## SERVICE BULLETIN

MODEL MX 73

### AIR CONDITIONER CIRCUIT BREAKER OPEN CIRCUIT

EL004-88

**[Location of Cowl Wire No. 2]**

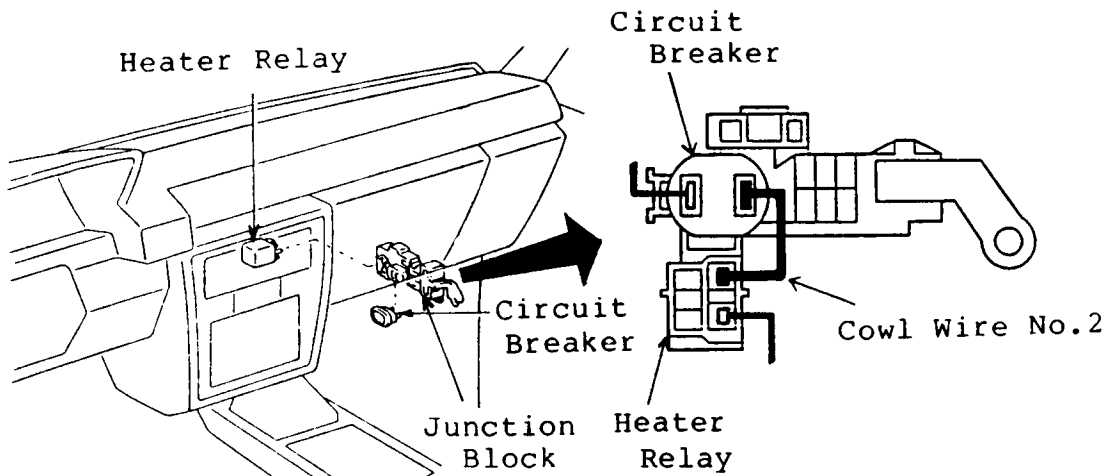
**SYMPTON:** When maximum fan blower speed is selected, the air conditioner becomes inoperative.

**CAUSE:** The air conditioner circuit breaker may open irregularly when the blower motor is operated at maximum-high speed after a few minutes. This condition is especially prevalent when the vehicle is parked for several hours in extremely high ambient temperatures.

**CORRECTION:** To prevent the circuit breaker from triggering open, the current capacity of the **cowl wire No. 2** has been increased in length and gauge size.
